Groundwater Application Review Summary Form

Application # G- 18430

GW Reviewer Aurora Bouchier Date Review Completed: May 30, 2017

TO: Water Rights Section Date May 30, 2017
 FROM: Groundwater Section Aurora C Bouchier
 SUBJECT: Application G- 18430 Reviewer's Name Aurora C Bouchier
 Supersedes review of na Date of Review(s) _____

Water-Level Trends in Nearby Wells

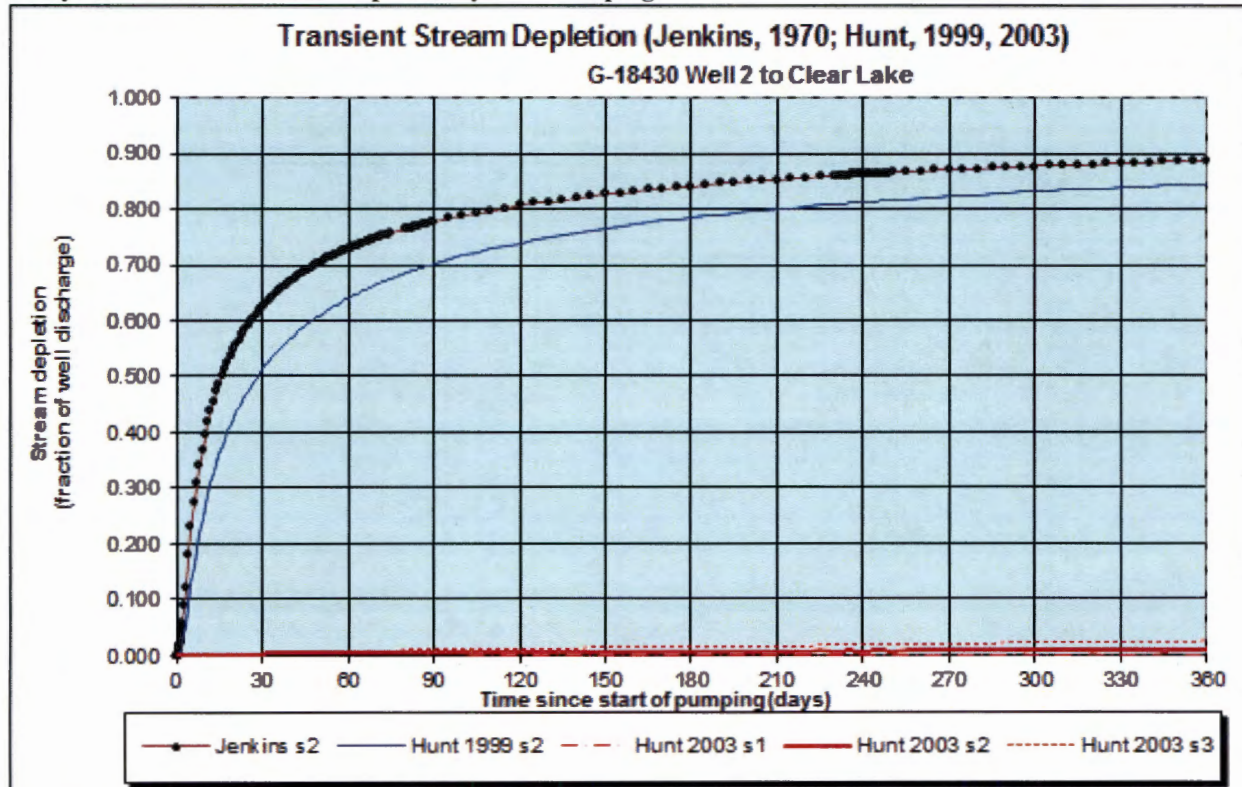
Observations from nearby wells indicate relatively stable long-term trends for alluvial wells in the immediate area of the proposed wells (see attached hydrograph), but increased groundwater development in the area indicates a need for additional water-level monitoring. In addition, the stated reason for related Transfer T-12361 is that “Production from the authorized Well 2 (MARI 17269) has decreased over time and no longer completely supplies our needs...” It is possible that the decrease in production is a result of decreased well efficiency. However, this speaks further to the need for additional water-level monitoring.
